NAPOLEON SUBDIVISION

APPLICATION NUMBER 13 DATE May 7, 2009

REQUEST Subdivision

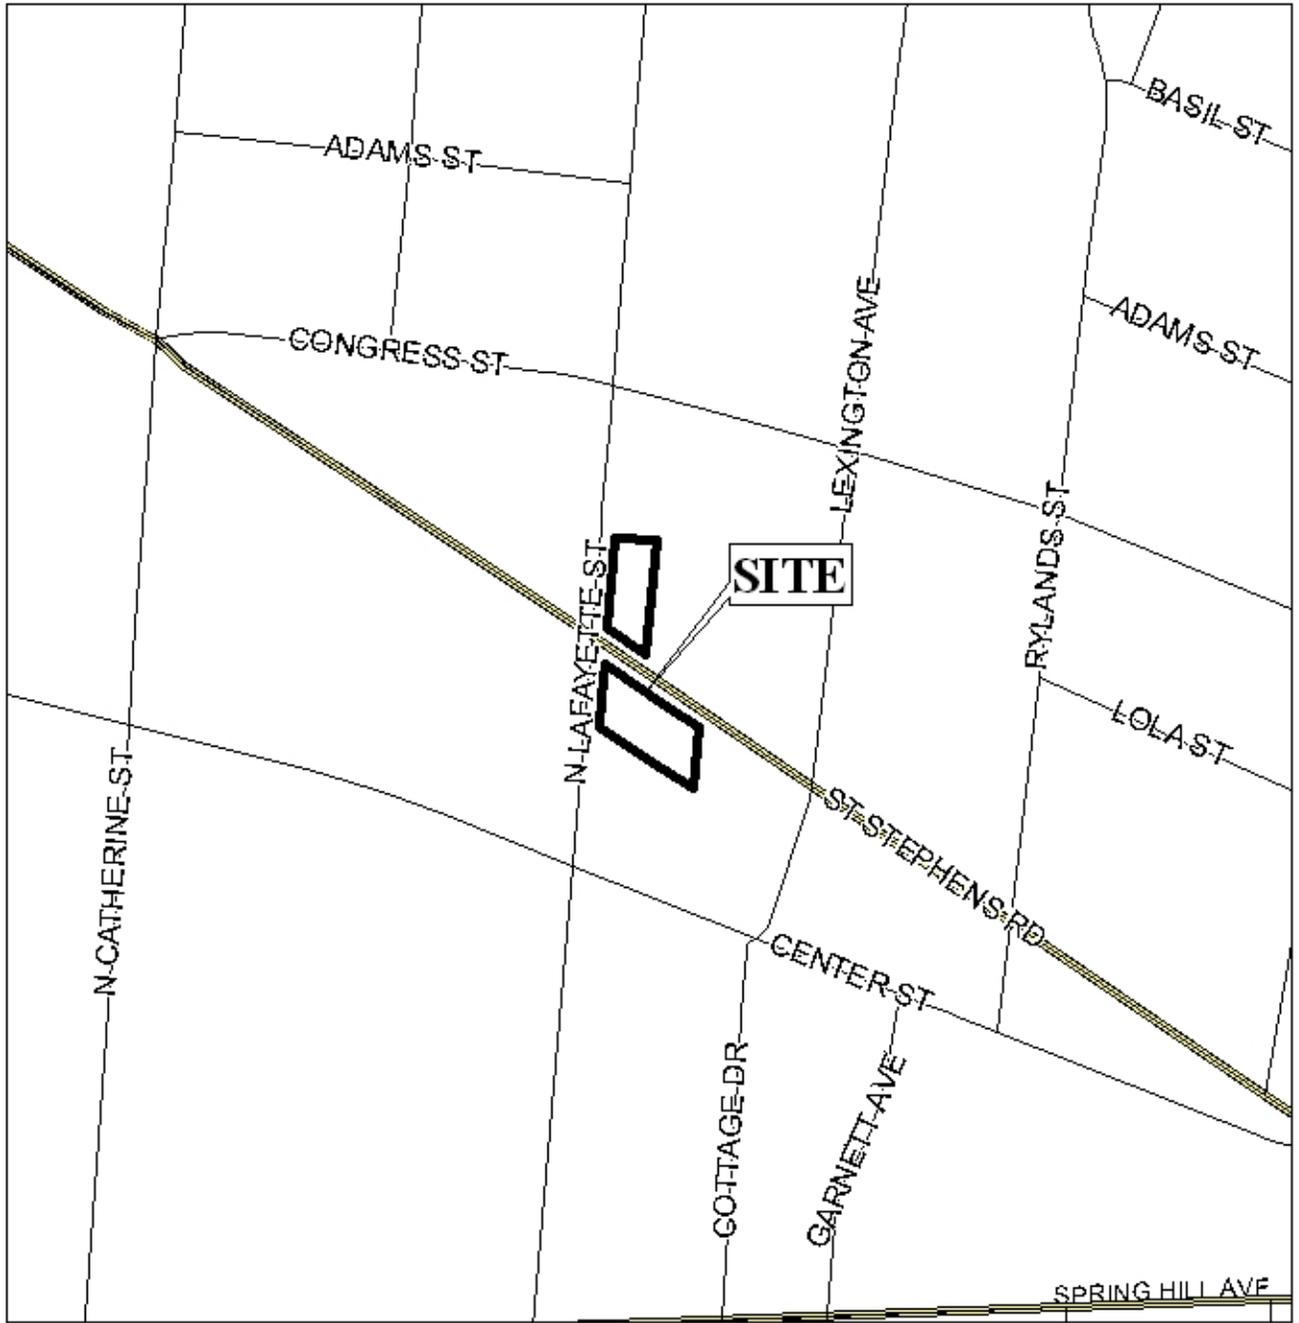
Engineering Comments: Must comply with all storm water and flood control ordinances. Any work performed in the right of way will require a right of way permit. Revised plat to include a minimum 25 foot radius to be dedicated to the City of Mobile at the intersection of St. Stephens Rd and Lafayette St. for both Lots. Drainage from dumpster pads cannot discharge to storm sewer; must have connection to sanitary sewer.

Traffic Engineering Comments: Driveway number, size, location, and design to be approved by Traffic Engineering and conform to AASHTO standards. Minimum parking aisle width is twenty-four feet. Changes should be made to accommodate this standard. There are also numerous conflict points in the parking lots that need to be remedied. Sufficient information is not provided for the driveway cuts and they appear substandard. Changes should be made to accommodate city standards.
